JICA Experts on Bengaluru Peripheral Ring Road Project

SUBJECT: Submission of Record of Discussions

Record of Discussion

Number	RD-PRR-DP-005
Objection	Technical Discussion based on Discussion Paper No. R02 & R03
Date	11 th May 2015 15:00~20:30
Venue	Meeting Room in DULT
Attendance	DULT : Mr. Shamanth K, Mr. Sivasubramaniam J BDA : Mr. Srinivask, Mr. H.C Ramendra, Mr. B Nagendra , Mr. Ajithkumar S.M STUP : Mr. T.V.Rajeev , Mr. Srivathsa B K JICA Experts: Mr. T. Tanaka, Mr. N. Kondo, Mr. S. Yamada
Handout	-Discussion Paper R02 (Road : Cross Sections, Vertical Alignment) -Discussion Paper R03 (Road : Junction/Toll Plaza/Rest Area)
Contents	<p>“Overall regarding Land Acquisition”</p> <p>Horizontal alignment will be reviewed based on the technical review by JICA Experts on DP R01 which technically required for fulfilling the design speed of 80km/h to accommodate within available ROW of BPRR. Final Decision will be taken by BDA after the revision in the detailed design.</p> <p>(It has to be confirmed by engineer member)</p> <p>“DISCUSSION PAPER R02 (Road: Cross Sections, Vertical Alignment)”</p> <p>1. Cross Sections</p> <p>1.1 General regarding Cross Sections</p> <p>Typical cross sec

3.1 Weaving Length of Old Madras Rd IC

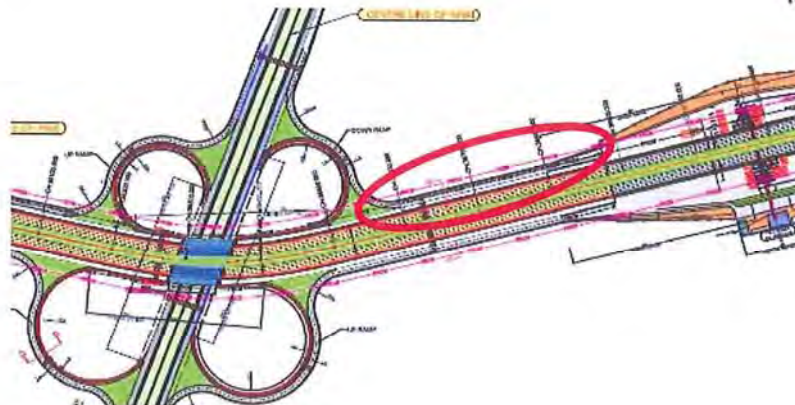
Length is too short for weaving

The car wants to enter the BPRR to Hosur direction by approaching from NH-4 Chennai side, needs to change the lane at least 3 times within short weaving section (around 200m).

It is easy to assume a large number of vehicles will keep coming since access is a major road (NH-4) and all drivers coming to entry lane at this IC need to change the lane maximum 4 times. JICA Experts recommend extending this portion within a limit of acquired land.

3.1 The weaving length between margining point of ramp and service road to entry toll plaza to Hosur direction should be longer since driver need to change the lane at least three times. BDA/STUP will reconsider the above as much as possible within the available land.

Figure 4.2 Redder of BPRR (current drawing)

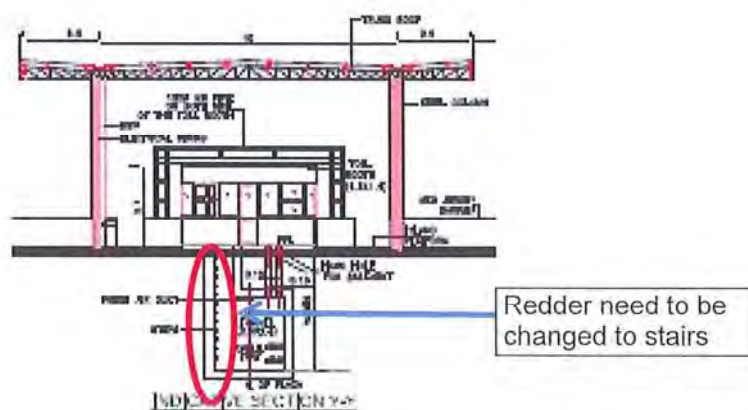
Tunnel for toll management is required for all toll plazas. JICA Experts confirmed most of the toll plazas have a plan of tunnels except Whitefield IC and one of Doodabalapura IC. However, redder has planned for toll booth to tunnel. Redder may cause inflict injury on staffs working for toll management. Especially toll collector need to carry cash box from toll booth to cash room and redder will be difficult for up and down. Gurugaon toll plaza has a toll management tunnel and connecting booth to tunnel by stairs as well as Hyderabad ORR.

Figure 4.3 Crash barrier deployment plan of BPRR

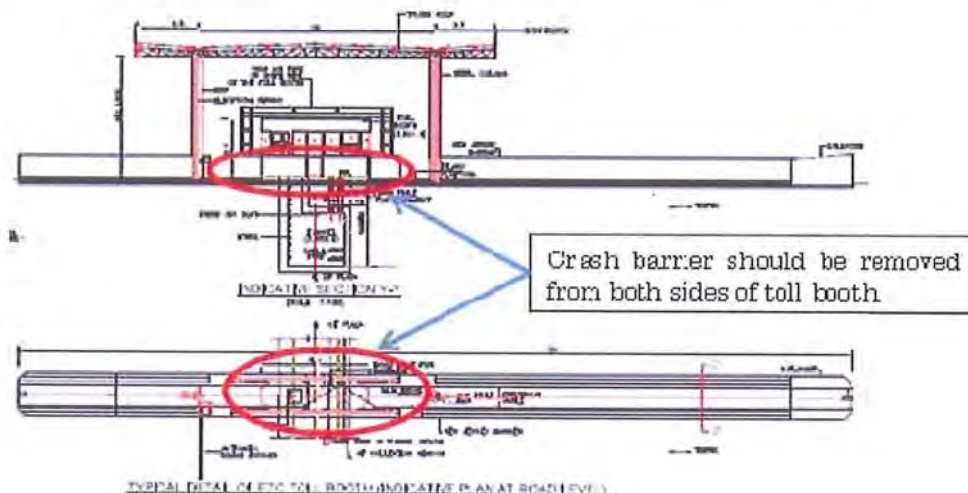
Crash barrier is not necessary for protecting toll booth since vehicle runs strait line on the toll lane which will be restricted by toll island. Without crash barrier,

Figure 4.5 Typical Layout of Toll Plaza (IRC:SP:99-2013)

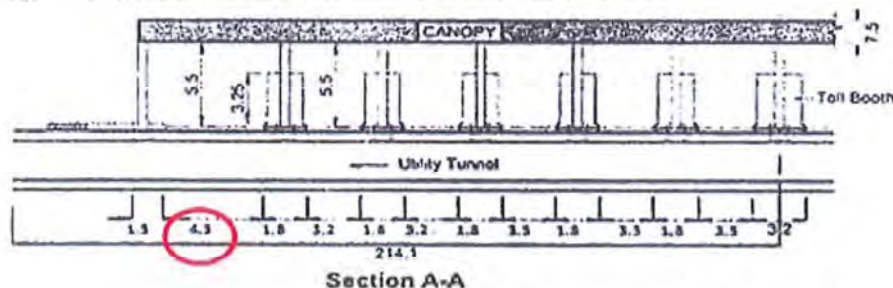
Width of large sized vehicle lane is described as 4.5m in IRC:SP:99-2013. However, DPR drawings are described 5.5m. Since toll plaza has to be constructed very much restricted area (100m width is right of way), JICA Experts recommend to reduce 1m of width of large sized vehicle lane as per IRC:SP:99-2013.
